Federal Motor Vehicle Safety Standards: Anti-Ejection Glazing for Bus Portals;

Mandatory Applicability Beginning October 30, 2027

ACTION: Final rule; partial grant of a petition for reconsideration

SUMMARY: This document partially grants a petition for reconsideration of the October 30, 2024 final rule that established Federal Motor Vehicle Safety Standard (FMVSS) No. 217a, “Anti-ejection glazing for bus portals; Mandatory applicability beginning October 30, 2027.”

Figure 1 to 49 CFR 571.217a – Guided Impactor

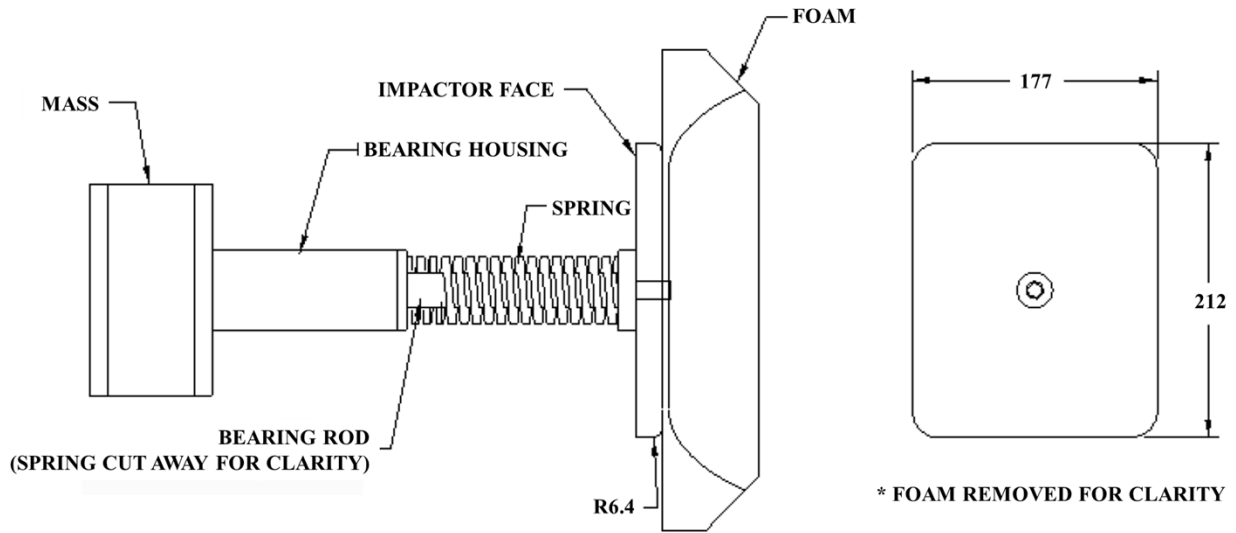
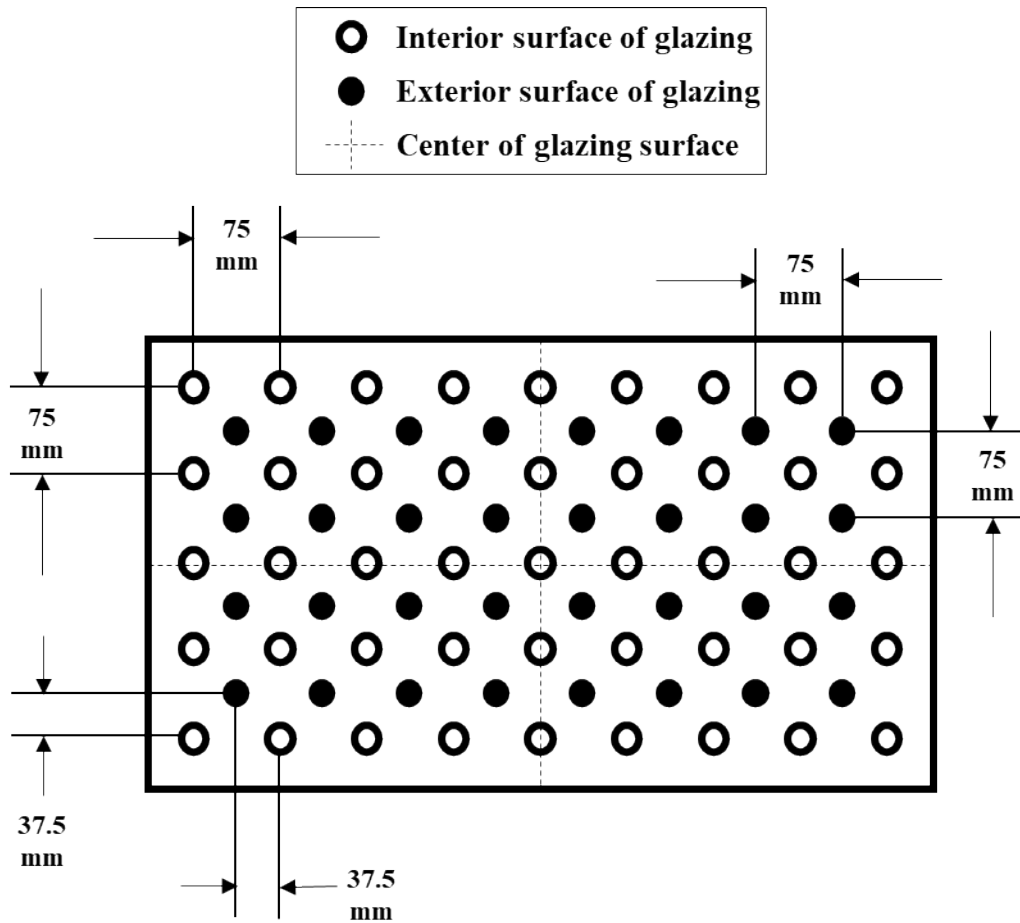
The second correction is in the figures in the regulatory text of the standard. As IC Bus noted, the figure numbers are not included in the figures. NHTSA is adding the figure numbers to those figures with this final rule.

- a. Revising the definition of “Daylight opening” and adding the definition of “Latch attachment point” in S4;
- b. Revising S5;
- c. Revising the introductory text of S6.1.1;
- d. Revising Figure 1 and Figure 2; and
- e. Adding Figure 3.

Figure 3 to 49 CFR 571.217a – An example of a daylight opening periphery (for illustrative purposes only)

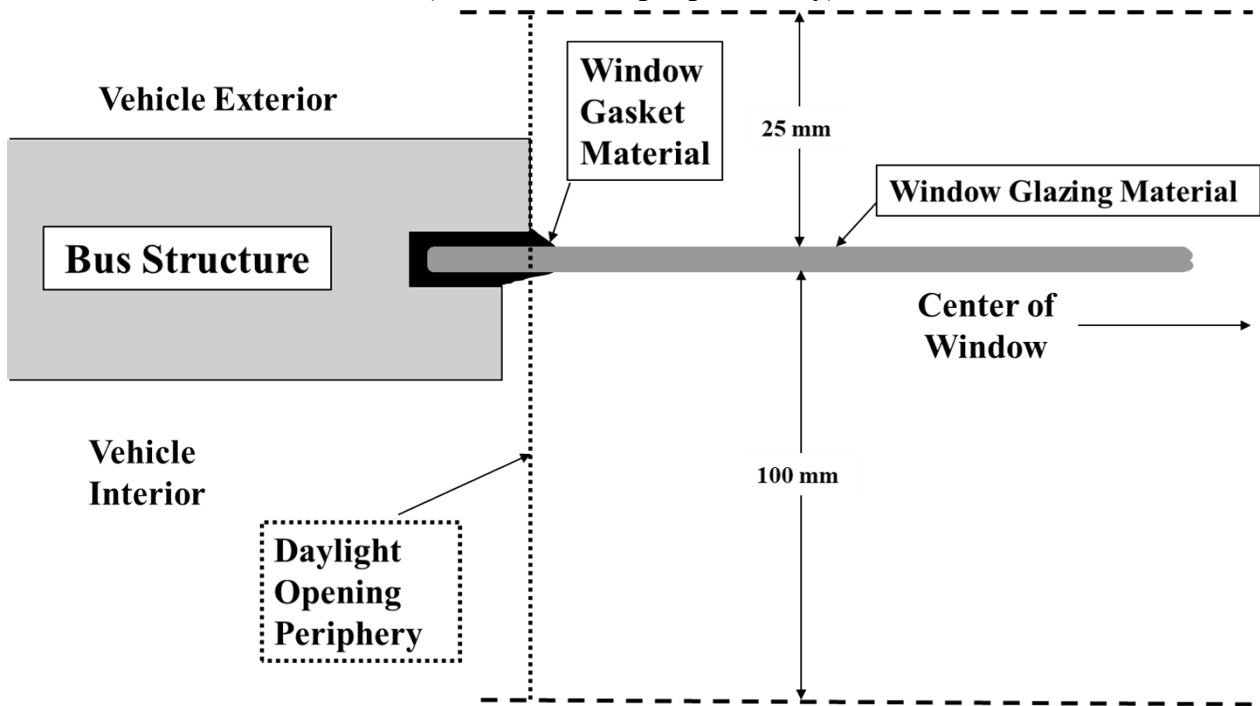
Next, IC Bus requested that Figure 7 in the Technical Support Document,⁹ which was submitted to the docket with the FMVSS No. 217a final rule, be included in the standard. The purpose of that figure and the Technical Support Document was to provide helpful context and examples for aspects of the final rule. This supplemental document and the figures within it will remain accessible on the public docket to manufacturers or other interested parties. However, NHTSA agrees with IC Bus that the figure could be a helpful addition to the regulatory text by making it easier for manufacturers to understand how to determine the daylight opening periphery. This figure is for illustrative purposes only and does not represent all possible daylight opening configurations. Therefore, NHTSA is adding the figure to the regulatory text

and amending the definition of “daylight opening” to include the following sentence: “An example of a daylight opening periphery is provided in Figure 3 for illustrative purposes only.”

Daylight opening means, for openings on the side of the vehicle (other than a door opening), the locus of all points where a horizontal line, perpendicular to the vehicle longitudinal centerline, is tangent to the periphery of the opening. For openings on the roof of the vehicle, daylight opening means the locus of all points where a vertical line is tangent to the periphery of the opening. The periphery includes surfaces 100 millimeters (mm) inboard of the inside surface of the window glazing and 25 mm outboard of the outside surface of the window glazing. The periphery excludes the following: Any flexible gasket material or weather stripping used to create a waterproof seal between the glazing and the vehicle interior; grab handles used to facilitate occupant egress and ingress; a restraining barrier; and any part of a seat. An example of a daylight opening periphery is provided in Figure 3 for illustrative purposes only.
